Third-Party Review of Gibson/USD Group Operational Value Chain Carbon Emissions Model

Dr. Damien Hocking

Corelium Software

August 18th 2021

Figure 1

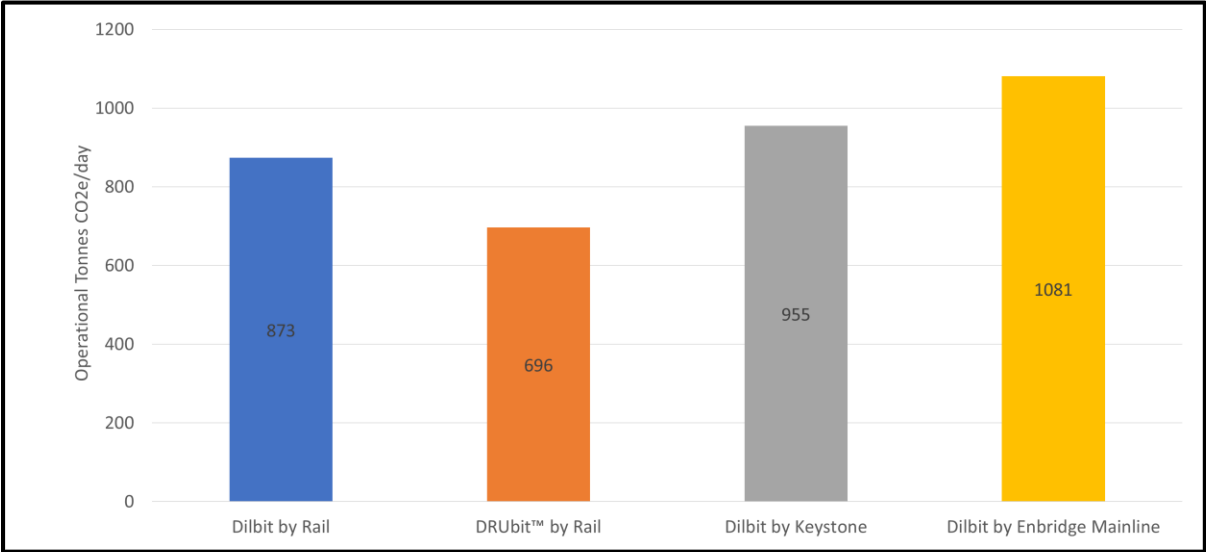
The model indicates that the DRUbit™ scenario above saves between 20% – 36% of operational CO_{2e} emissions compared to the Dilbit rail and pipeline scenarios. Against the Dilbit by rail scenario, the model predicts that the DRUbit™ scenario saves approximately 63,000 metric tonnes CO_{2e}/year (20%, 69,000 U.S. tons/year). Against the Keystone scenario, the model predicts that the DRUbit™ scenario saves approximately 92,000 metric tonnes CO_{2e}/year (27%, 101,000 U.S. tons/year). Against the Mainline scenario, the model predicts that the DRUbit™ scenario saves approximately 137,000 metric tonnes CO_{2e}/year (36%, 151,000 U.S. tons/year).

These savings are achieved by removing the diluent required to enable pipeline transport and replacing those pipeline transport emissions with rail transport emissions. Diluent is recovered at the upstream HET location instead of the downstream end-user refinery, removing the diluent transport loop and associated emissions. A comparison of the predicted total emissions for each scenario is shown in Figure 1 below.

Figure 3

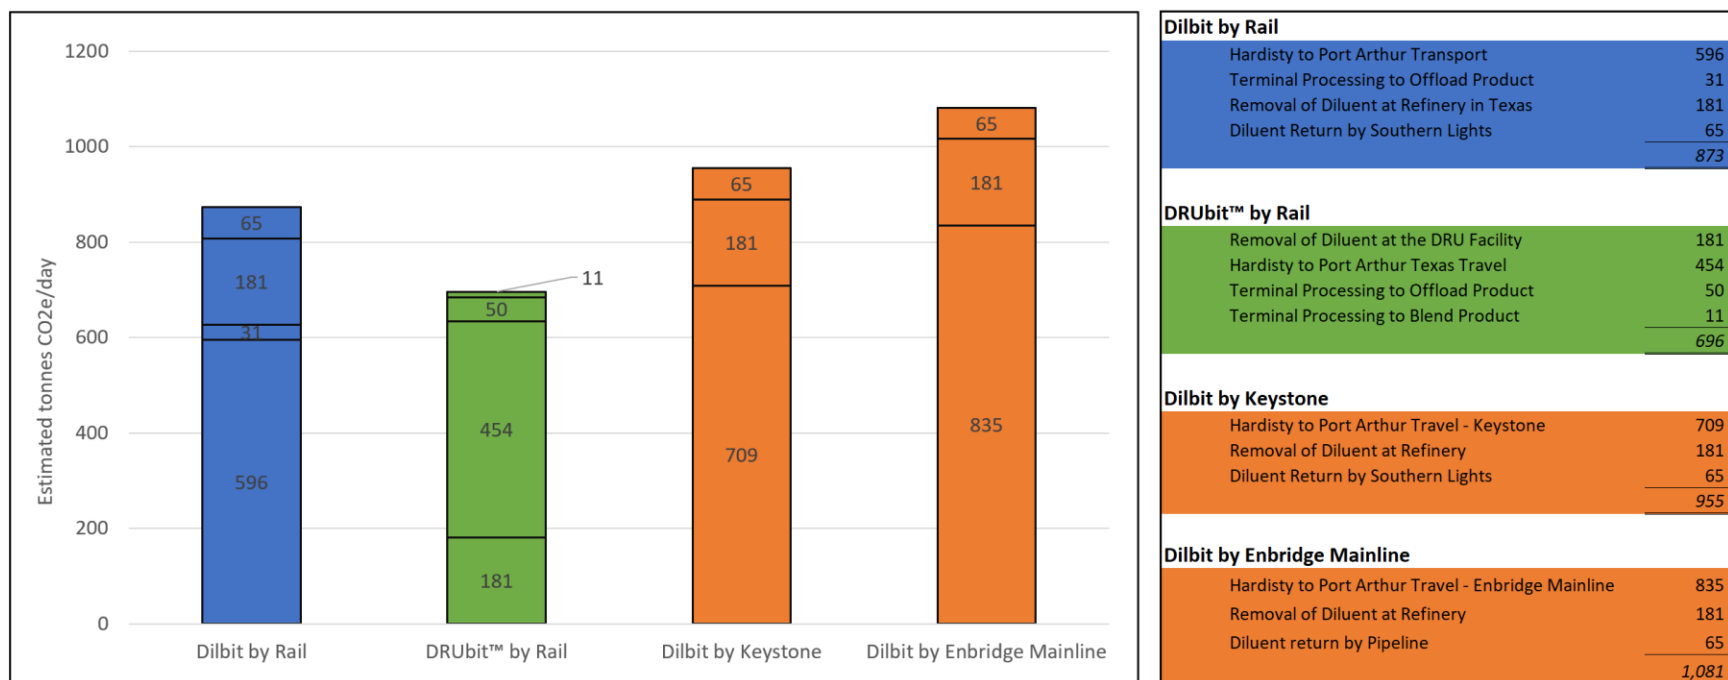
The model indicates that the DRUbit™ scenario above saves between 20% – 36% of operational CO₂e emissions compared to the Dilbit rail and pipeline scenarios. Against the Dilbit by rail scenario, the model predicts that the DRUbit™ scenario saves approximately 63,000 metric tonnes CO₂e/year (20%, 69,000 U.S. tons/year). Against the Keystone scenario, the model predicts that the DRUbit™ scenario saves approximately 92,000 metric tonnes CO₂e/year (27%, 101,000 U.S. tons/year). Against the Mainline scenario, the model predicts that the DRUbit™ scenario saves approximately 137,000 metric tonnes CO₂e/year (36%, 151,000 U.S. tons/year).

These savings are achieved by removing the diluent required to enable pipeline transport and replacing those pipeline transport emissions with rail transport emissions. Diluent is recovered at the upstream HET location instead of the downstream end-user refinery, removing the diluent transport loop and associated emissions.
